Planning Commission Q & A Report

Question Commissioner Shaw / Staff Response

SITE PLAN

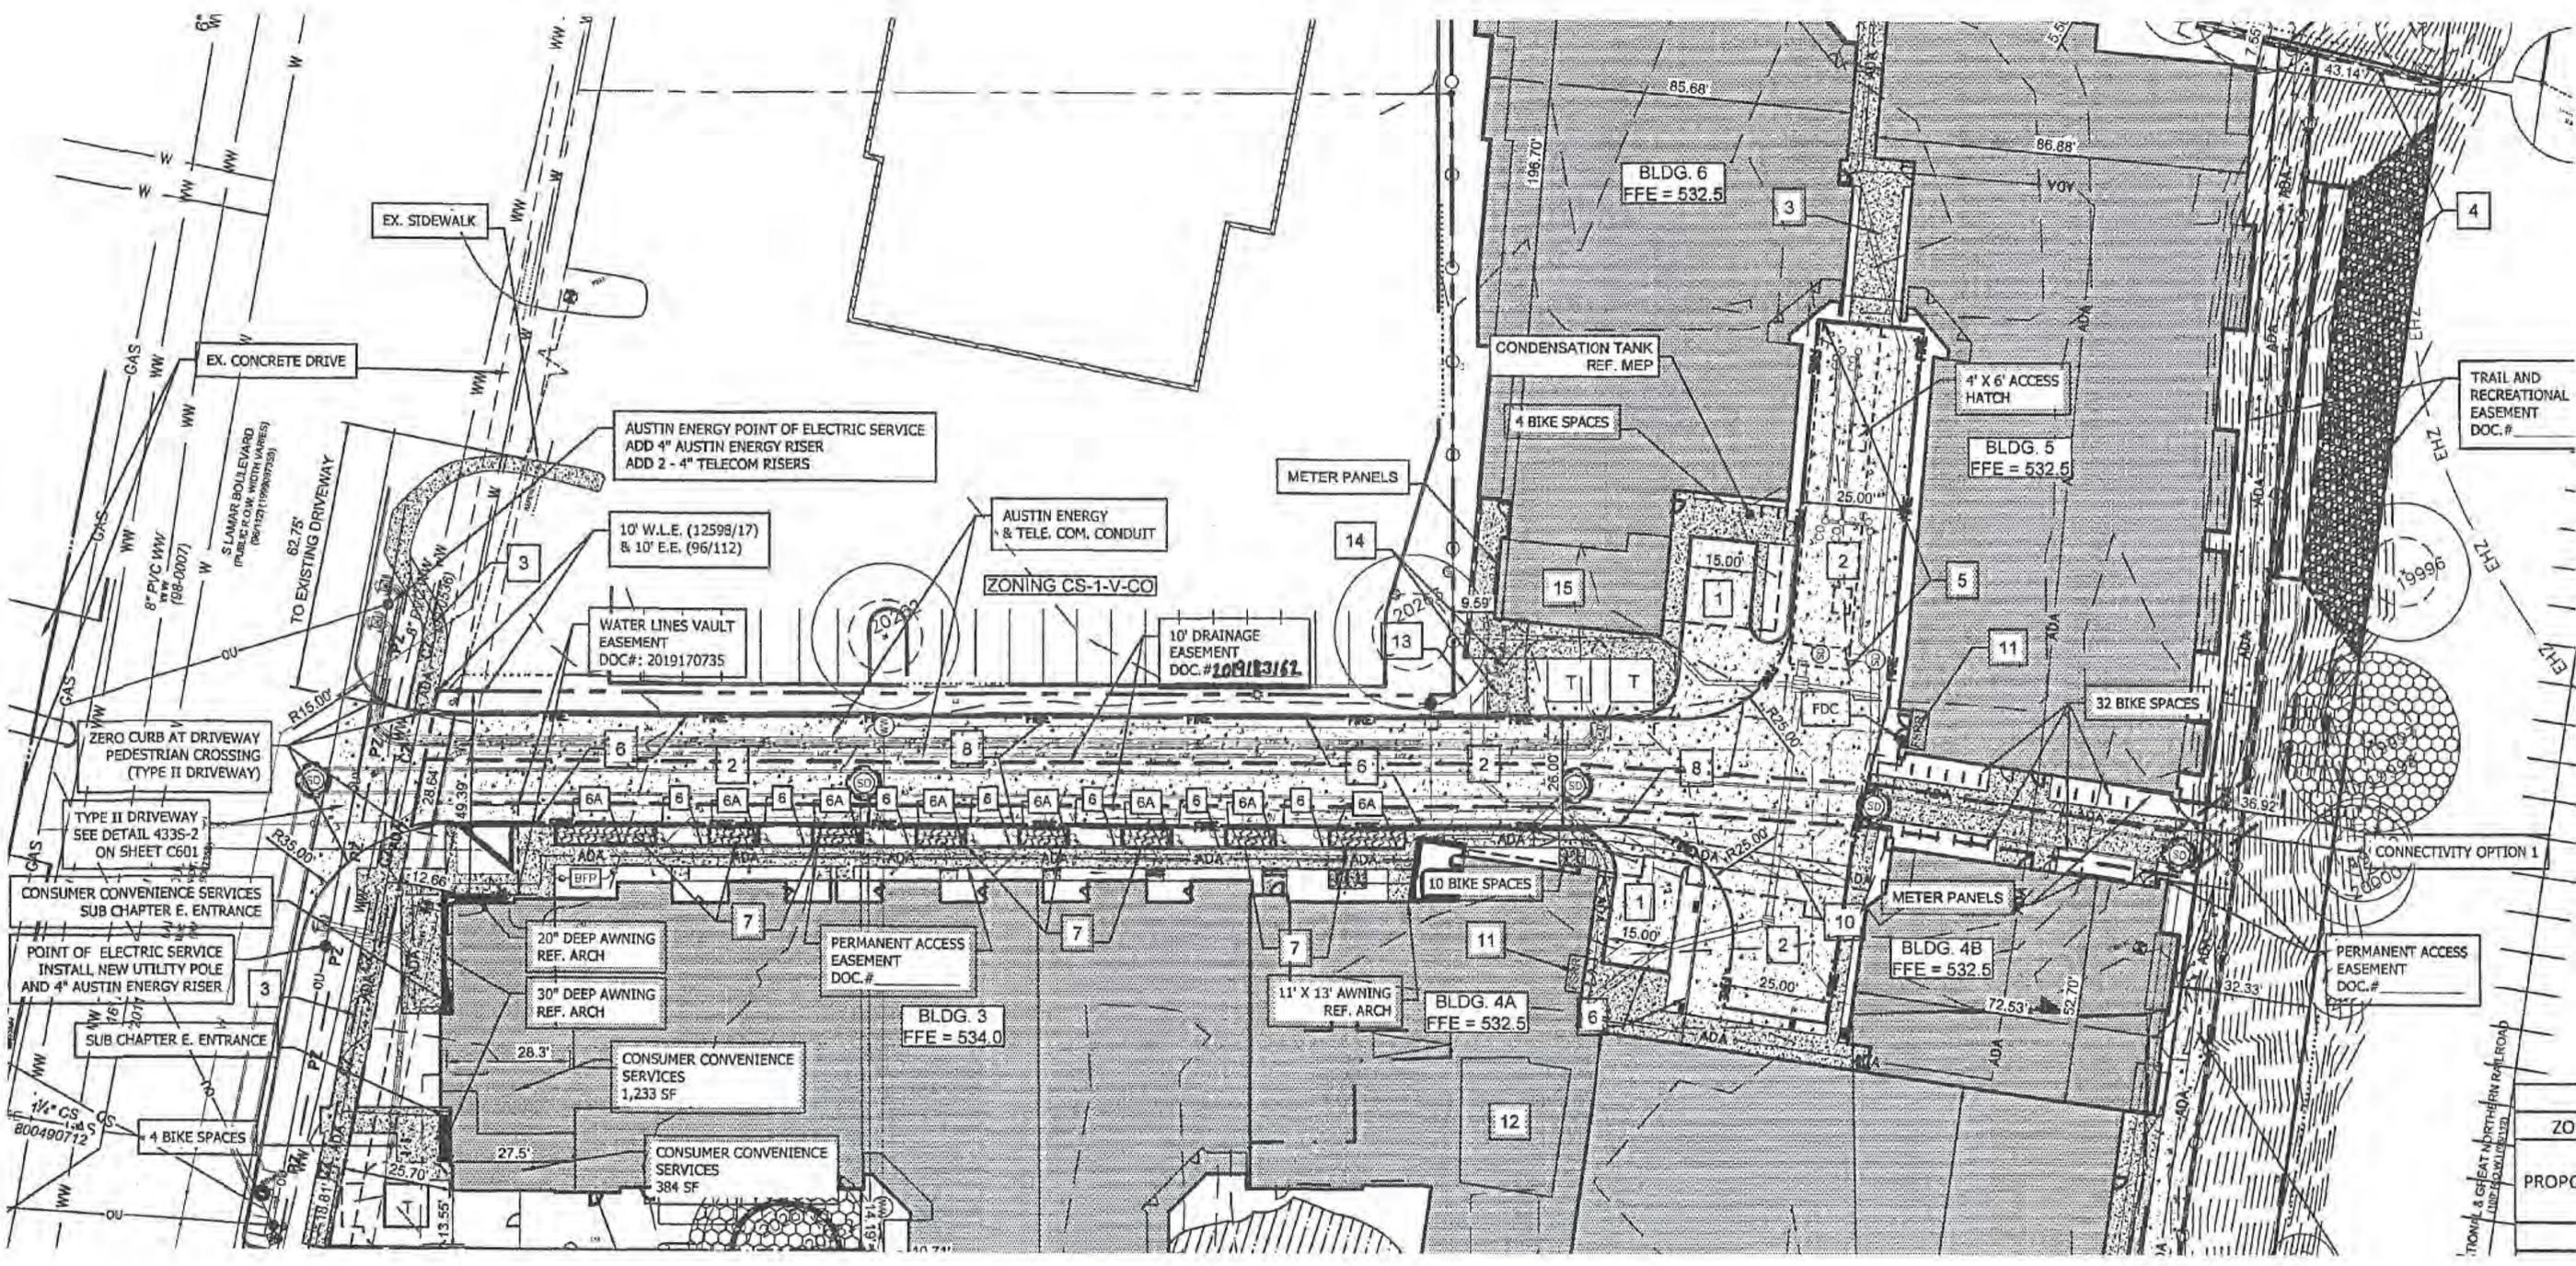
- **1515 S. Lamar (SP-2018-0595C)** – Code requires safe access to a trail to the rear of the site, achieved with a Public Access easement that runs along an existing sidewalk. Access doesn't have to be wide or change appearance; ensures that the trail is not alienated from the public in this location.

1515 S Lamar : 30 plus feet to work with and all of site w/o environmental constraints

SITE AND PAVING PLAN

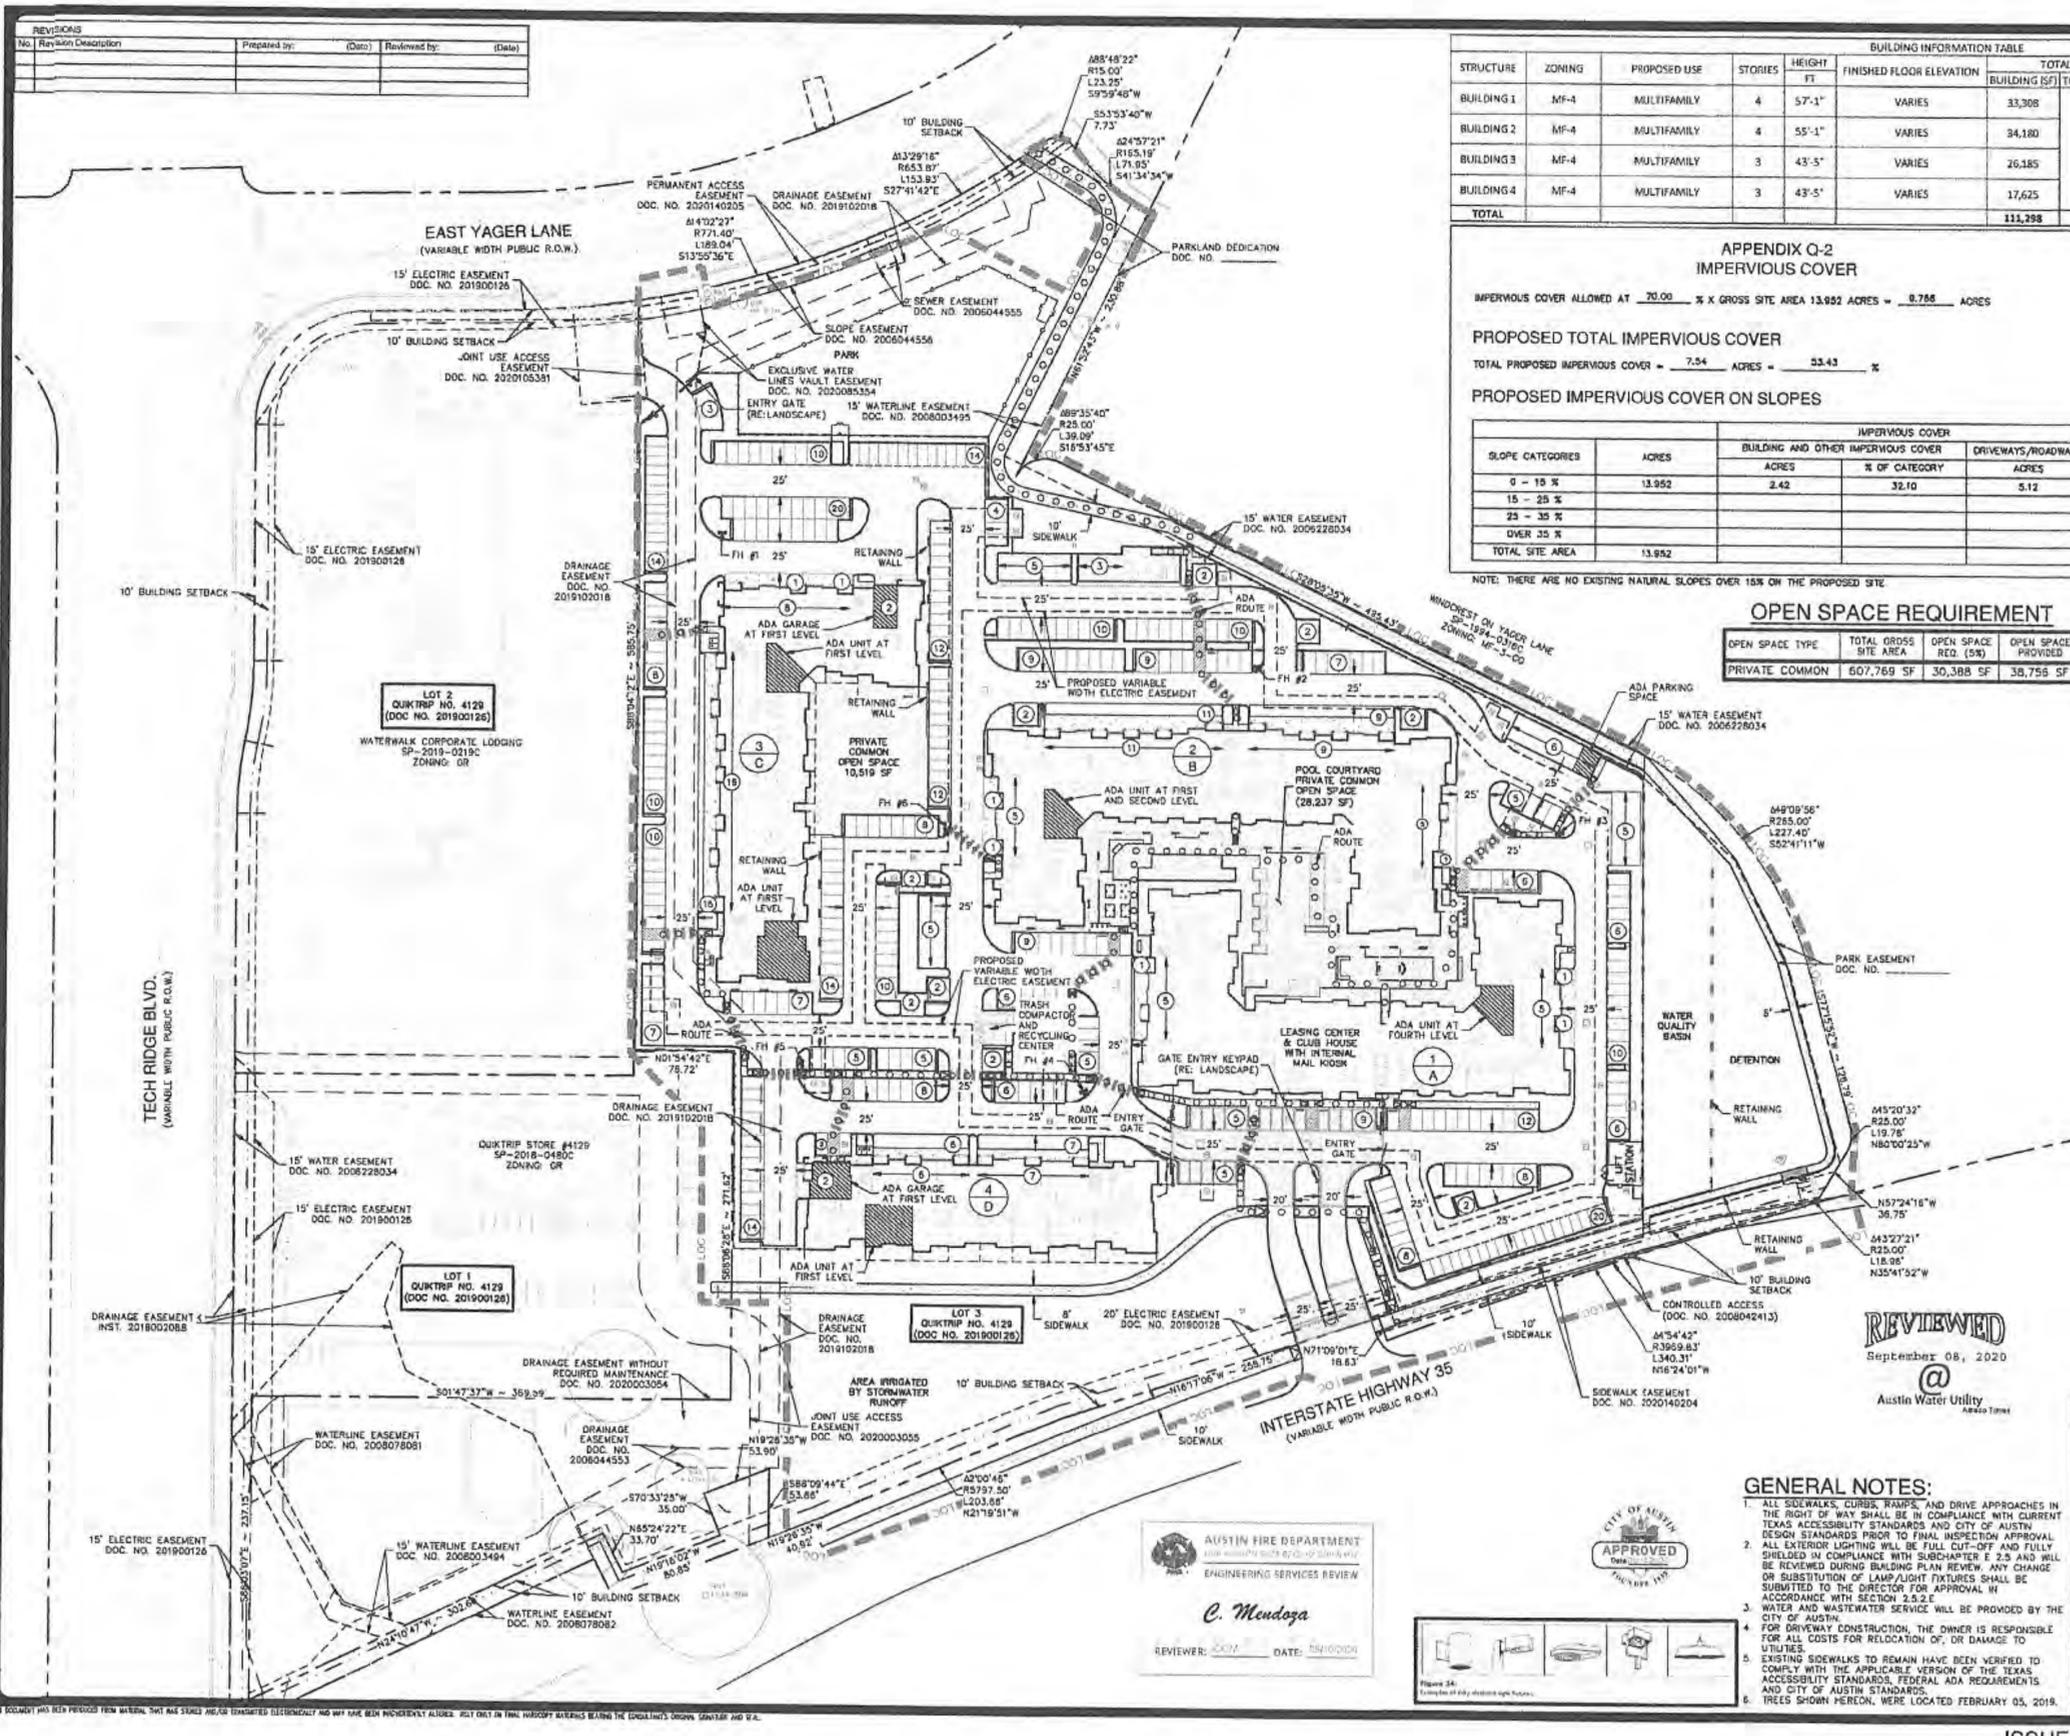
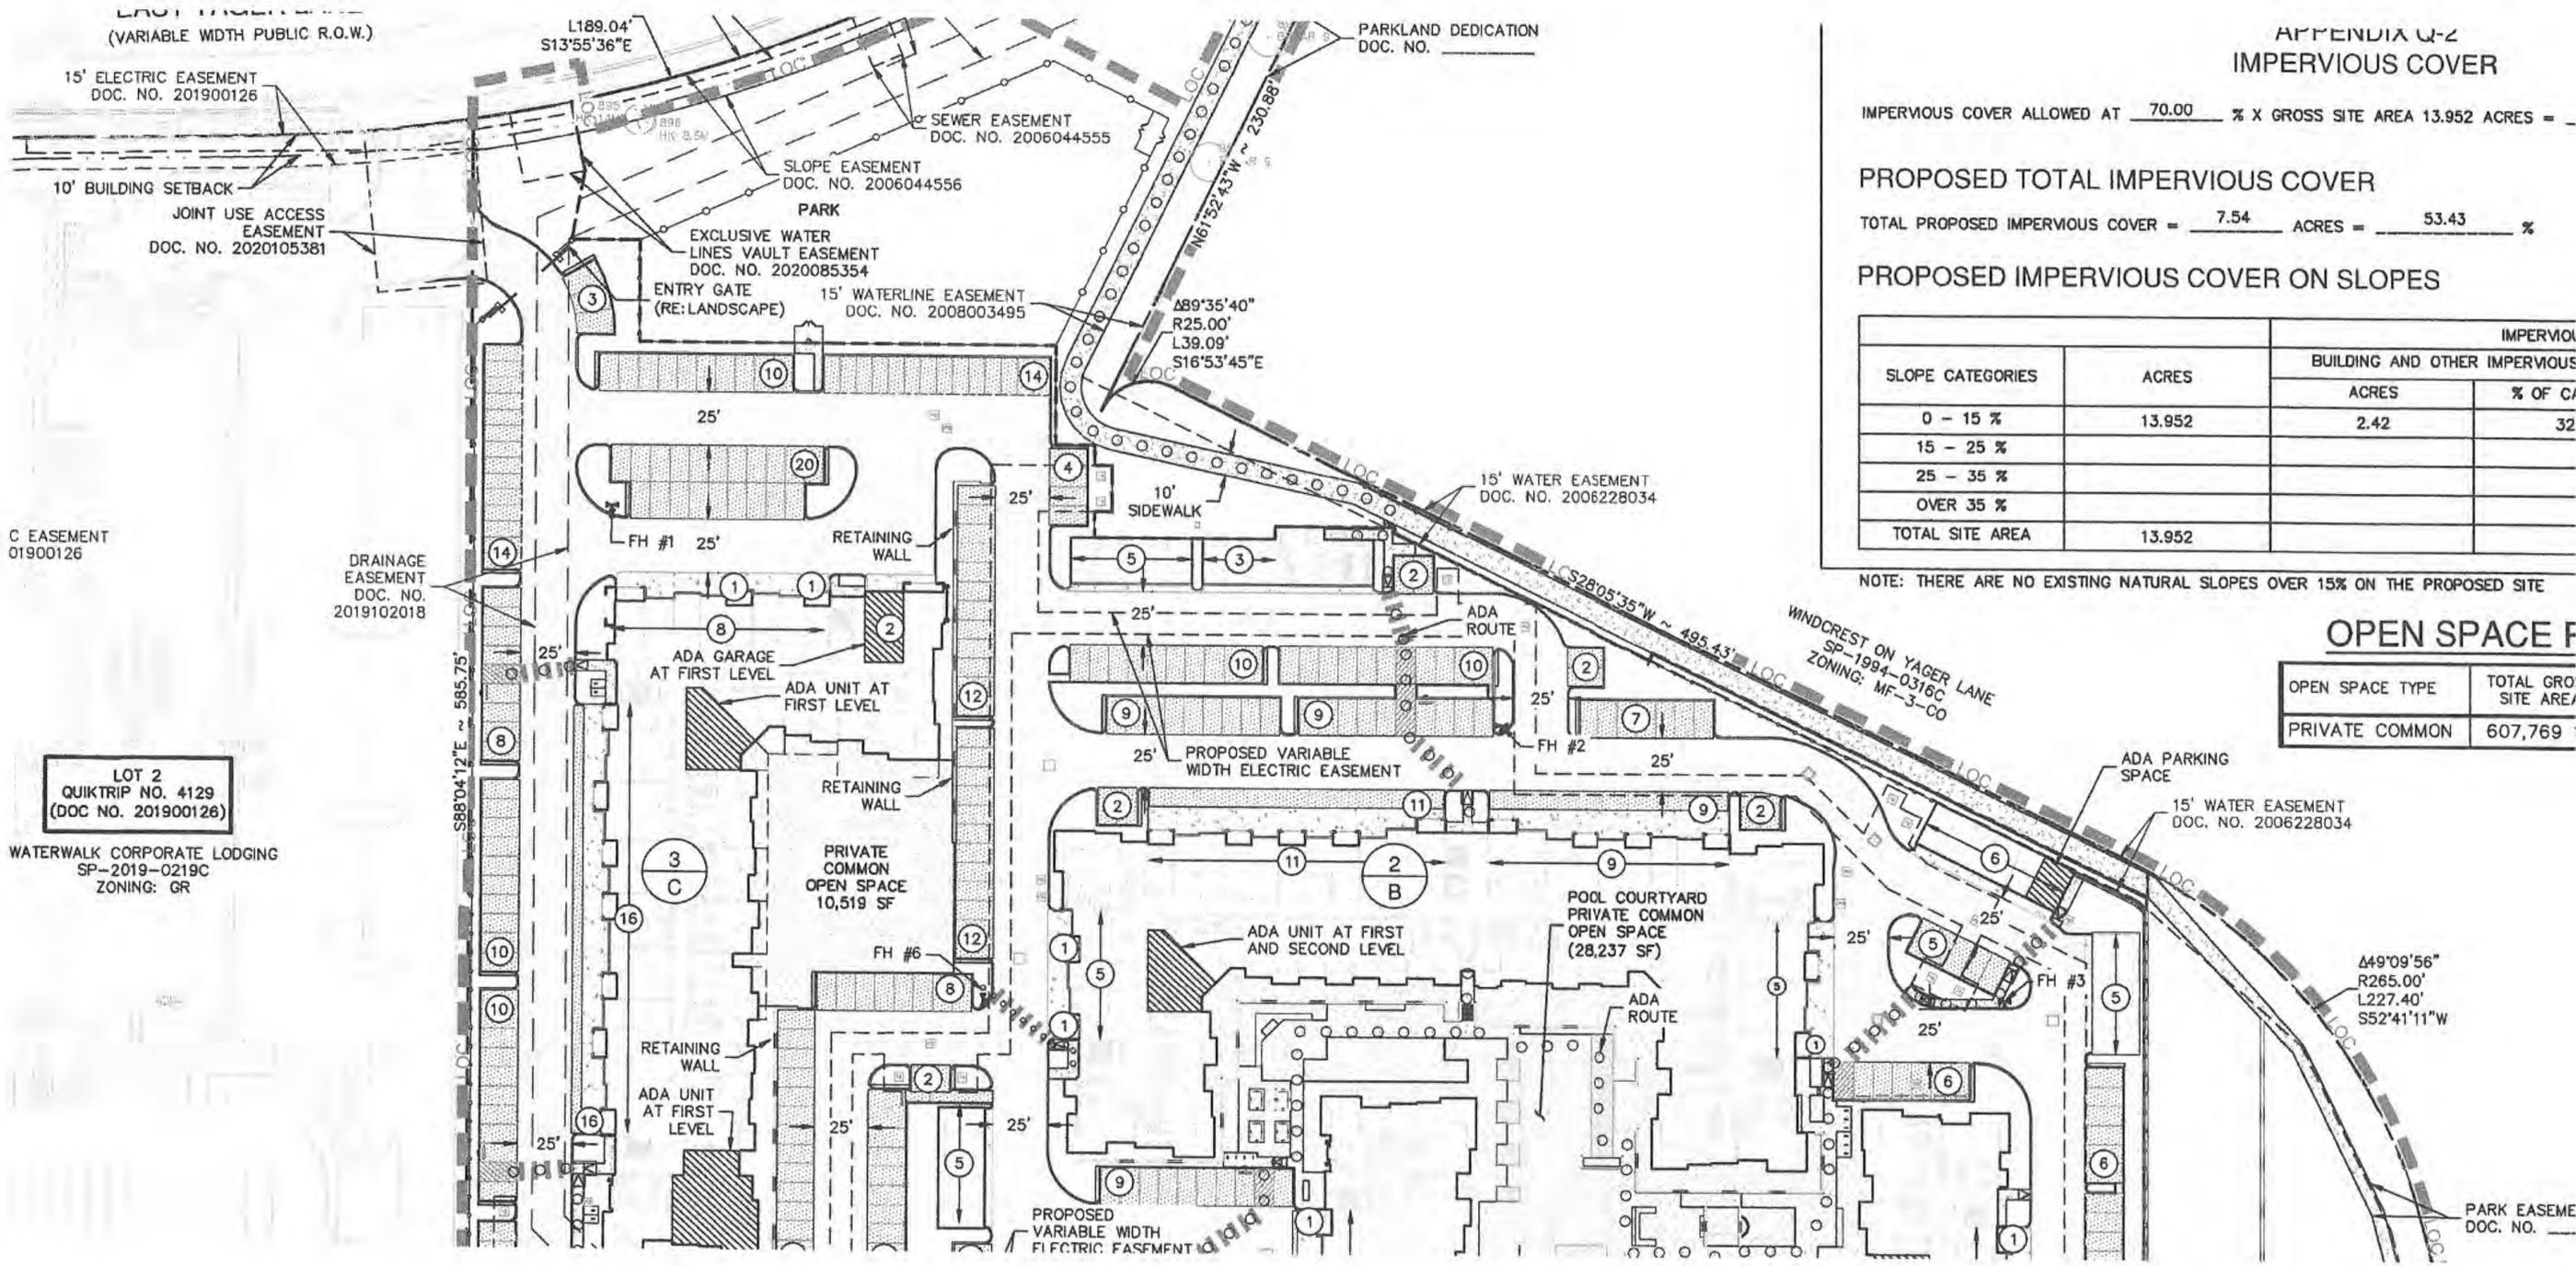
- **Tech Ridge (SP-2019-0262C – 12217 N. IH 35)** – Parkland dedication satisfied by deeded land and a park easement that will provide the community with a needed connection between ROW and a Park.

1311 S. Lamar; no site plan ever released/ no project
12217 N. IH. 5; huge site . lots of buildable area and street frontage
5900 Cameron Road; lots of street frontage and buildable area
